Case No.: DC1 2005-00113

Project Name: Bonita 30 RPD

A ZONING ORDINANCE OF THE CITY OF BONITA SPRINGS, FLORIDA; APPROVING A REQUEST BY COLONIAL HOMES IN REFERENCE TO BONITA 30 RPD; TO REZONE FROM AG-2 (AGRICULTURAL) TO RPD (RESIDENTIAL PLANNED DEVELOPMENT); ON LAND LOCATED AT 25251 TROPIC ACRES DRIVE, BONITA SPRINGS, FLORIDA, (STRAP NO. 23-47-25-B2-00002.0000), ON 23.56 +/- ACRES; PROVIDING FOR AN EFFECTIVE DATE.

BONITA 30 RPD
MASTER CONCEPT PLAN

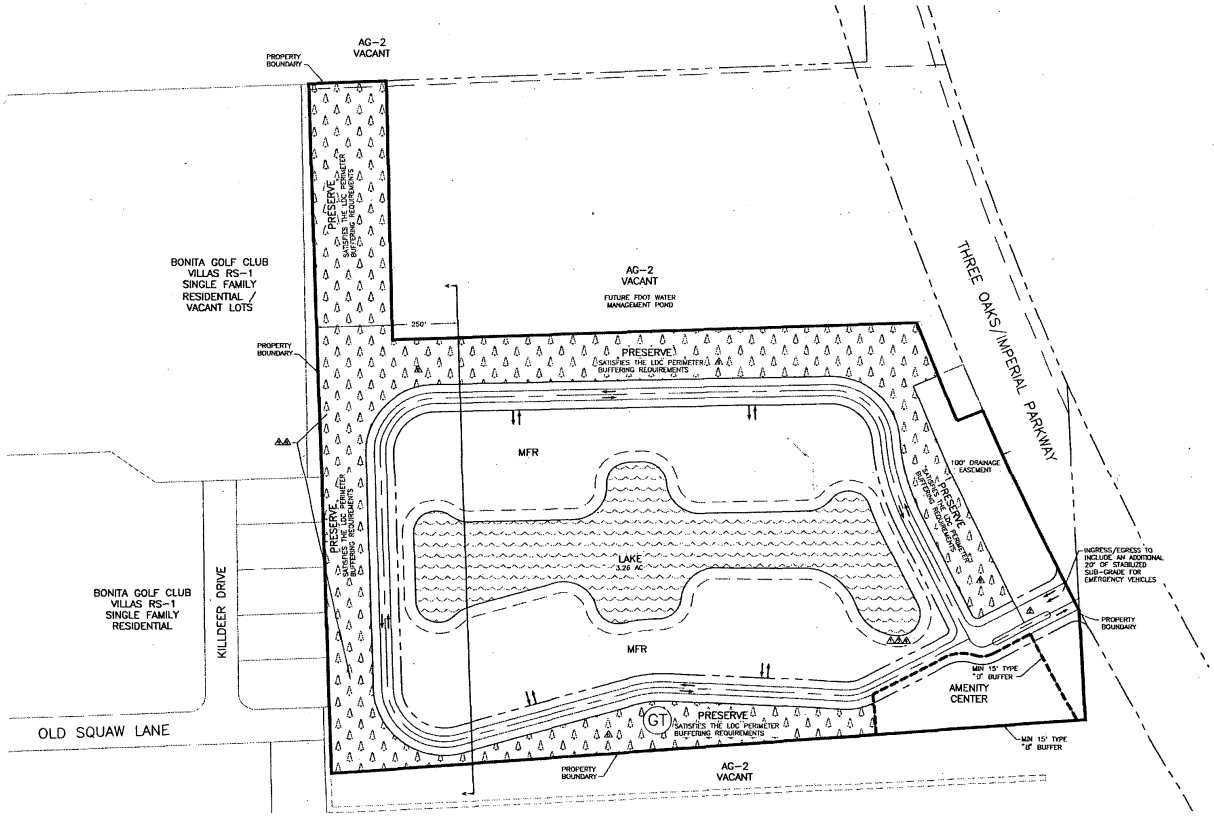
3- The full access median opening configuration with inbound (left turn) and outbound (left turn) storage lanes shown per sheet 3 of 3 but the 240' southbound right turn lane is not shown.

Figure 2A

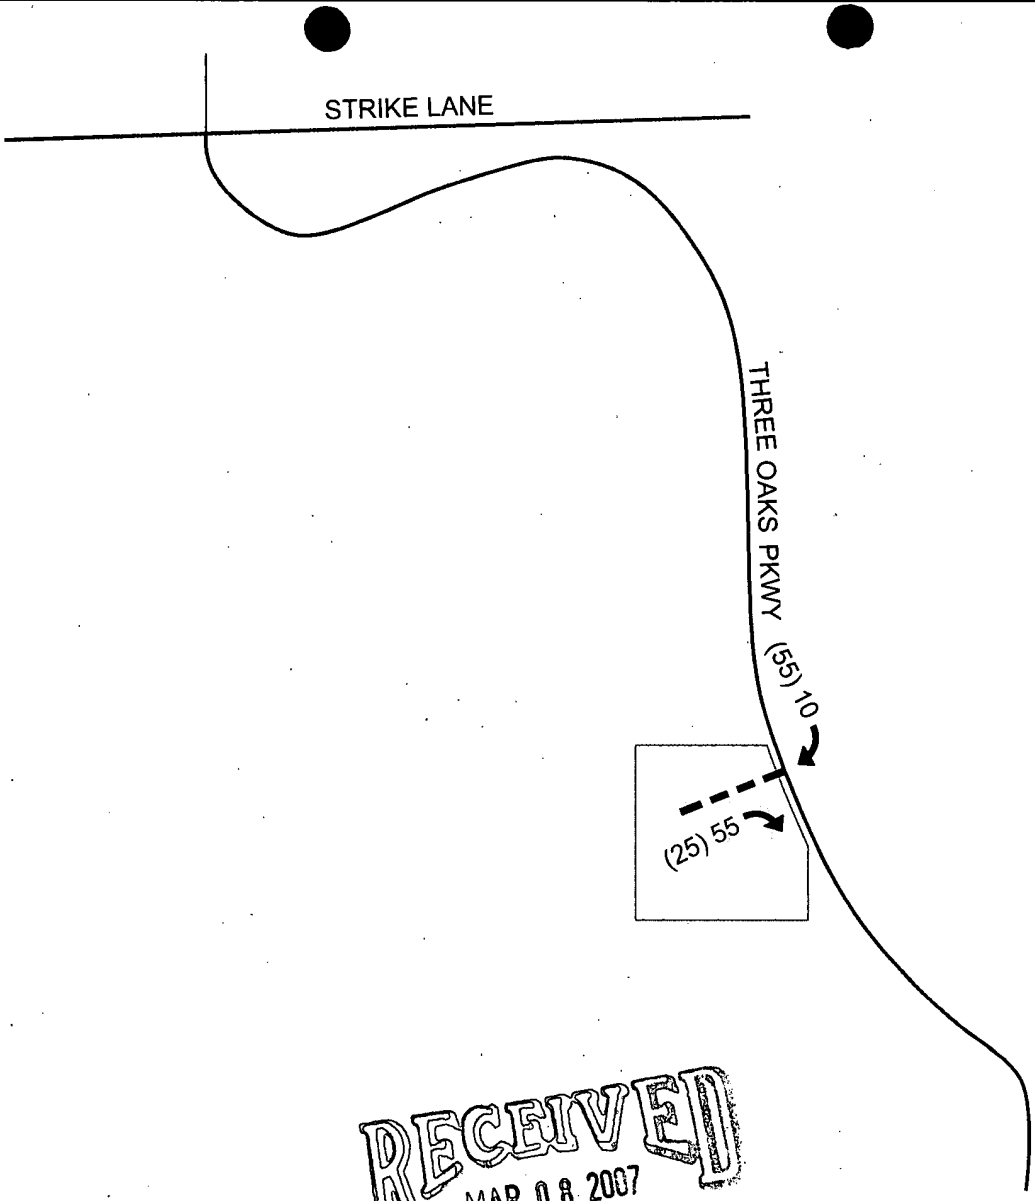
Based on the revised trip generation indicated in Table 1, the A.M. peak hour trip generation of the subject site was reduced by five (5) vehicles and the P.M. peak hour trip generation remained the same. Figure 2A illustrates the revised project traffic distribution for the subject site based on the current right-in/right-out only access to Three Oaks Parkway. Figure 2B illustrates the site traffic assignment to the site access drive.

PLAN AND PROFILE SHEET STA 214+80 TO STA 220+40

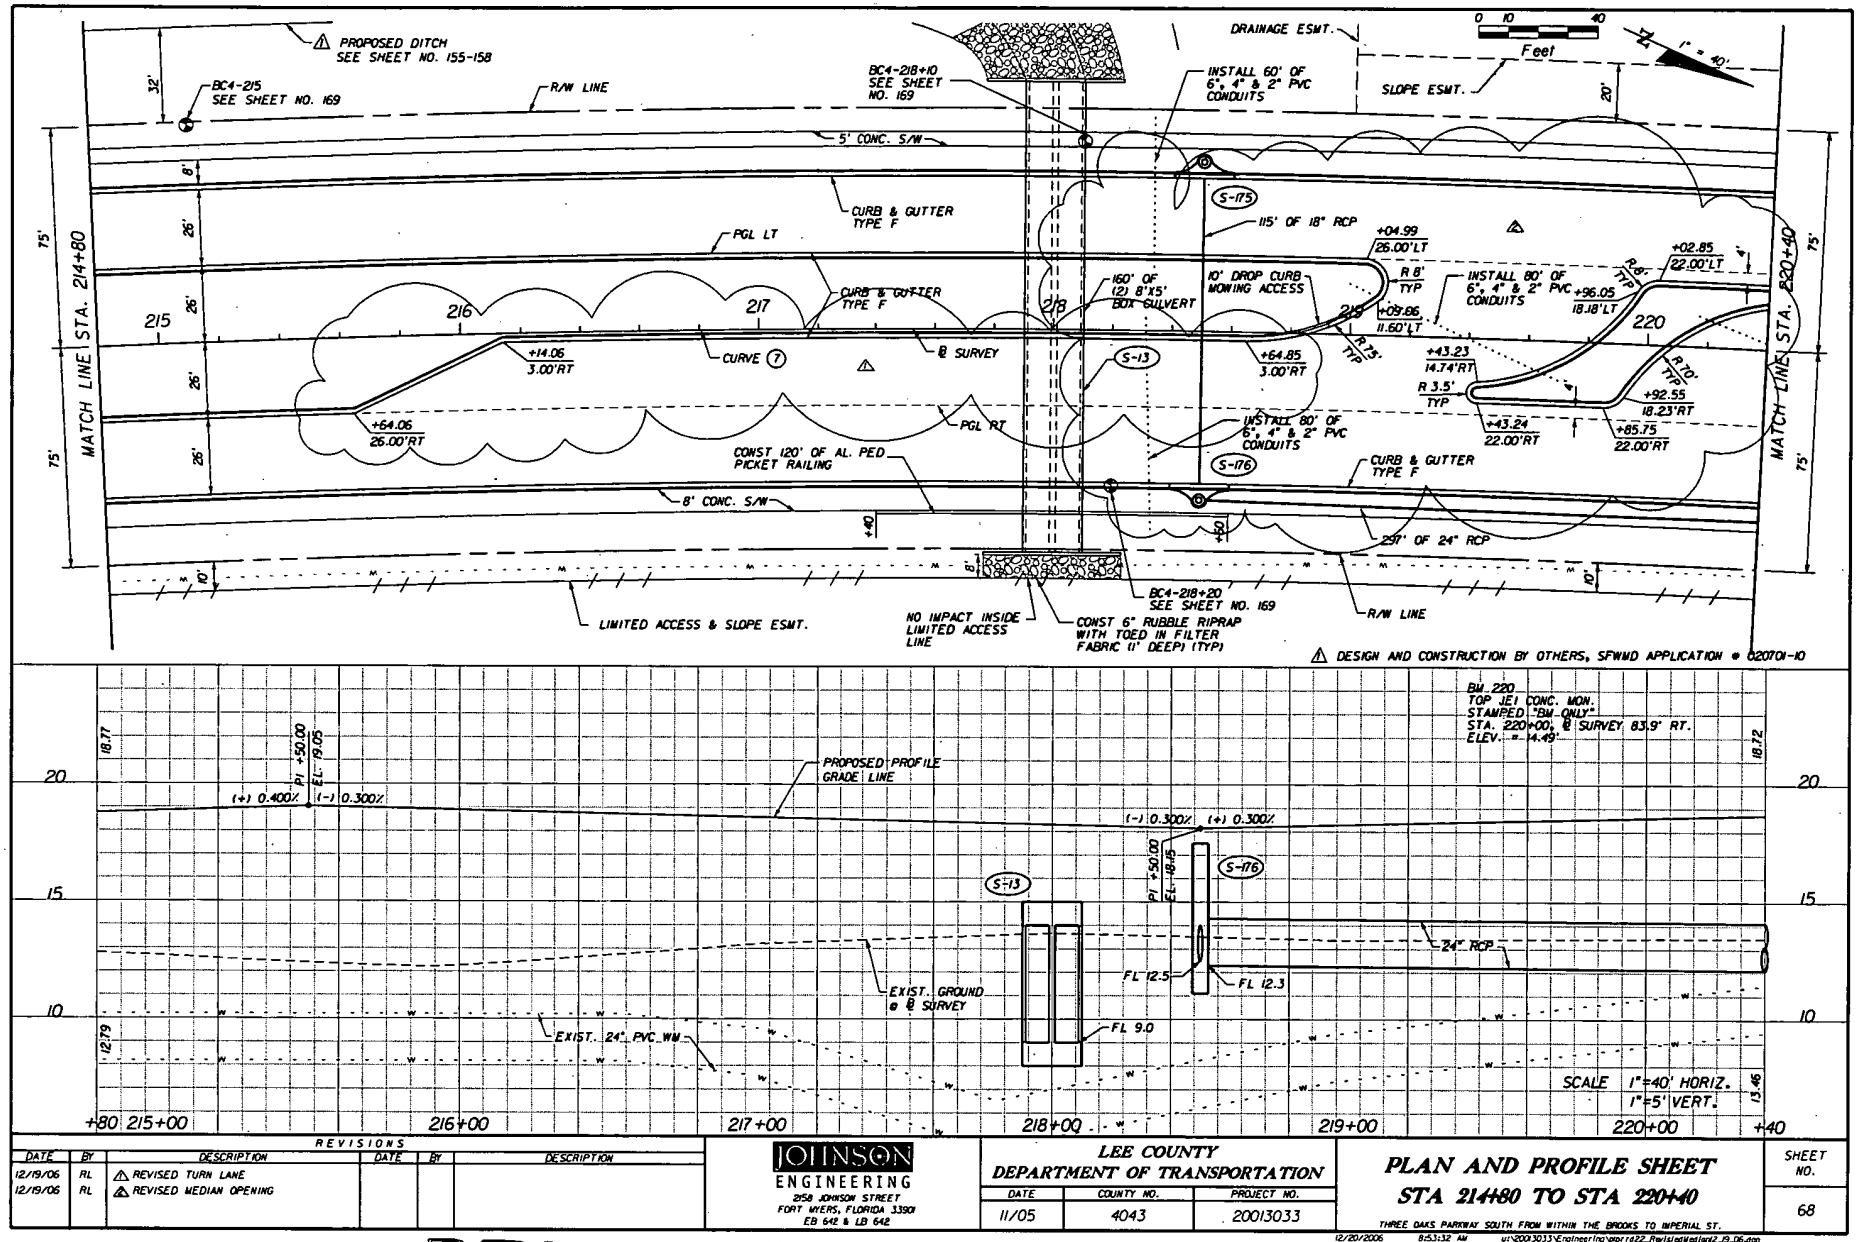
REVISIONS					
DATE	BY	DESCRIPTION	DATE	BY	DESCRIPTION
12/19/06	RL	⚠ REVISED TURN LANE			
12/19/06	RL	⚠ REVISED MEDIAN OPENING
